DEPARTMENT OF TRANSPORTATION

Docket No. FAA-2012-1168; Airspace Docket No. 07-AWA-3

Proposed Modification of the Dallas/Fort Worth Class B Airspace Area; TX

ACTION: Notice of proposed rulemaking (NPRM).

DALLAS/FT WORTH, TX
07-AWA-03
REVISE CLASS B AIRSPACE
DALLAS-FT WORTH TAC
1:250000

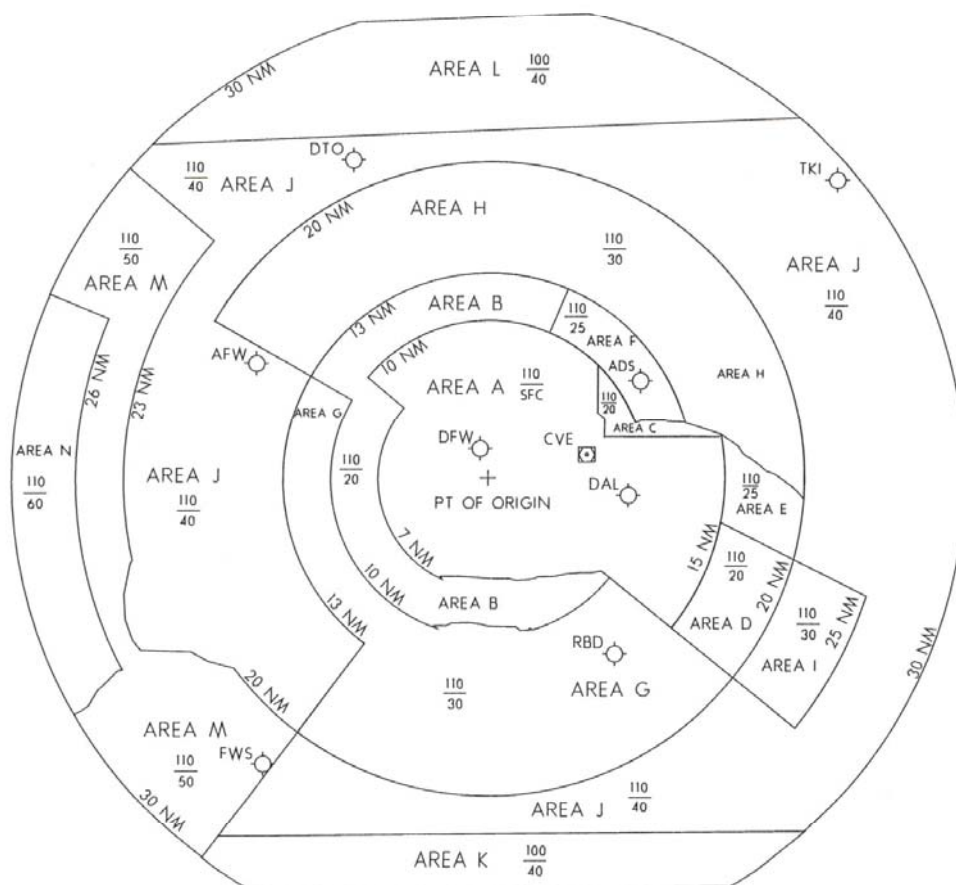
The FAA is proposing an amendment to Title 14 of the Code of Federal Regulations (14 CFR) part 71 to modify the Dallas/Fort Worth, TX, Class B airspace area. This action (depicted on the attached chart) proposes to lower the northern portion of existing Area G located northwest of DFW to 4,000 feet MSL, lower a portion of existing Area D located northeast of

DFW between the 10-NM and 13-NM arcs from the Point of Origin to 2,500 feet MSL, lower approximately the southern half of existing Area C located southeast of DAL to 2,000 feet MSL, lower a portion of existing Area E located southeast of DAL between the 20-NM and 25-NM arcs from the Point of Origin to 3,000 feet MSL, and redefine the northern boundary of the Class B airspace area using the Ray Roberts Lake dam. The Class B airspace ceiling would remain unchanged. These proposed modifications to the Dallas/Fort Worth Class B airspace area would provide the minimum airspace necessary to contain the existing large turbine-powered aircraft flying instrument procedures to and from DFW and DAL within the confines of Class B airspace.

Area D. Area D is a new area extending upward from 2,000 feet MSL to 11,000 feet MSL located southeast of DAL from the Cowboy VOR/DME (CVE) 117°T/111°M radial clockwise to the 129°T/123°M bearing from the Point of Origin and between 15-NM and 20-NM of the Point of Origin. This new area would lower a portion of Class B airspace contained in the current Area C, south of the CVE 117°T/111°M radial, by 500 feet to overcome the issue of aircraft arriving DAL runways 31R and 31L from the southeast exiting the bottom of the Class B airspace shelf with a 2,500 foot MSL floor and then reentering the side of the Class B airspace surface area.

Area F. Area F is a new area extending upward from 2,500 feet MSL to 11,000 feet MSL located northeast of DFW from the 023°T/017°M bearing from the Point of Origin clockwise to Interstate I-635 and between 10-NM and 13-NM of the Point of Origin. This new area would lower a portion of Class B airspace contained in the current Area D, northeast of DFW, by 500 feet to overcome the issue of aircraft arriving DAL runways 13R and 13L from the northeast exiting the bottom of the Class B airspace shelf with a 3,000 foot MSL floor, flying through the ADS Class D airspace area, and then reentering the side of the Class B airspace shelf with a

Area I. Area I is a new area extending upward from 3,000 feet MSL to 11,000 feet MSL located southeast of DAL from the Cowboy VOR/DME (CVE) 117°T/111°M radial clockwise to the 129°T/123°M bearing from the Point of Origin between 20-NM and 25-NM of the Point of Origin. This new area would lower a portion of Class B airspace contained in the current Area E by 1,000 feet to overcome the issue of aircraft arriving DAL runways 31R and 31L from the southeast exiting the bottom of the Class B airspace shelf with a 4,000 foot MSL floor and then reentering the side of the Class B airspace shelf with a 2,500 foot MSL floor.

Area J. Area J extends upward from 4,000 feet MSL to 11,000 feet MSL in the Class B airspace contained in the current Area E with an extension northwest of DFW that would include a portion of Class B airspace contained in the current Area G, northwest of the 311°T/305°M bearing from the Point of Origin. This new area would overcome the issue of aircraft arriving DFW runways 13R and 13L from the northwest exiting the bottom of the Class B airspace shelf with a 5,000 foot MSL floor and then reentering the side of the Class B airspace shelf with a 4,000 foot MSL floor.

Area L. Area L extends upward from 4,000 feet MSL to 10,000 feet MSL in the Class B airspace contained in the current Area F that is located north of DFW. The FAA is proposing to extend the northern boundary further north, parallel to the existing boundary, to intercept the southern-most point of the Ray Roberts Lake dam for visual reference.
